Revised August 11, 2008

Subtask 2.3. Track, Signal and Grade Crossing

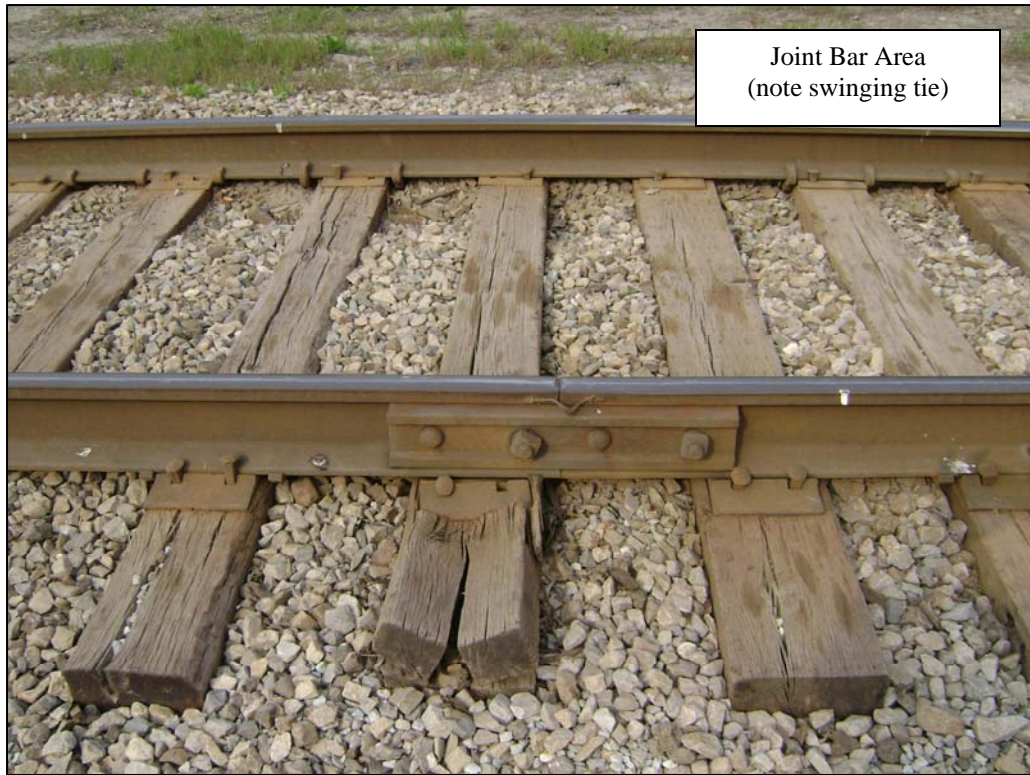
Additionally, a mid-day layover track is proposed to be constructed at the east end of Osmer Siding (see photo at top of next page) consisting of a hand-throw switch (off of the siding) providing access to a single 5,000 foot side track. Standby power would be supplied at this location as well. Access to this layover track would be by gravel road.

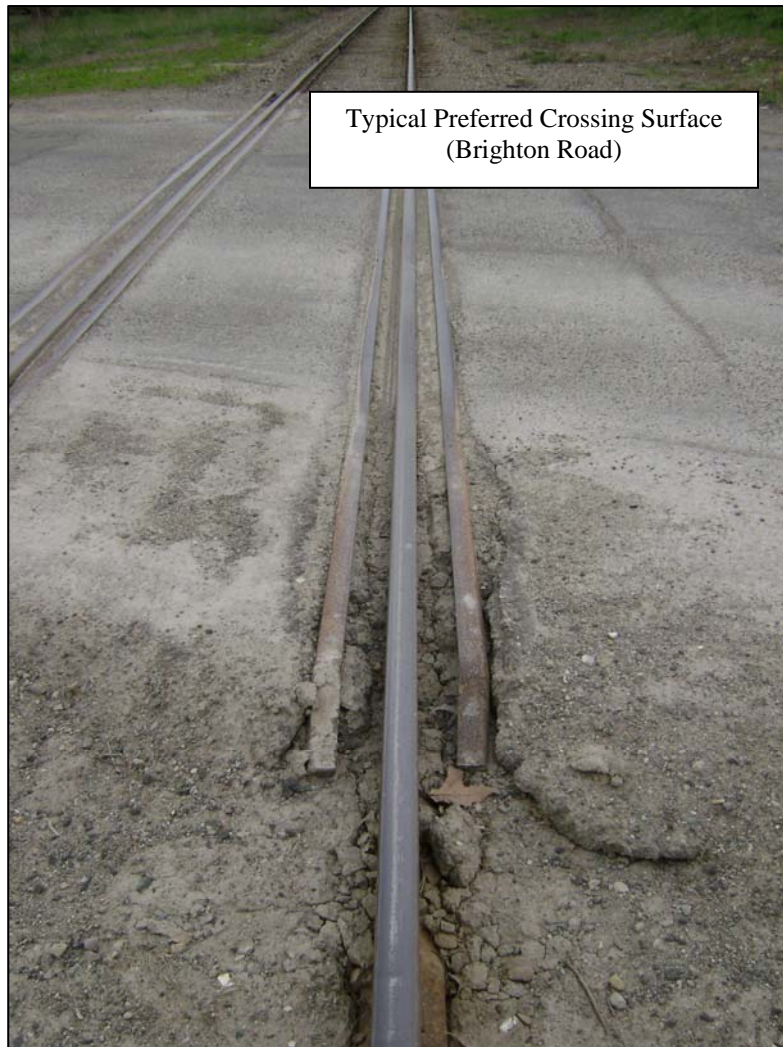
GLC representatives informed RLBA that, at the time of the hyrail inspection trip, four culverts needed repair or replacement. To account for other potential repairs before startup of passenger rail service, RLBA estimates that about one culvert every five miles would be replaced. Cost estimates in the next section reflect these assumptions.

Cost estimates reflect replacement of existing culverts (whatever the type) with a bituminous-coated corrugated metal pipe (CMP).
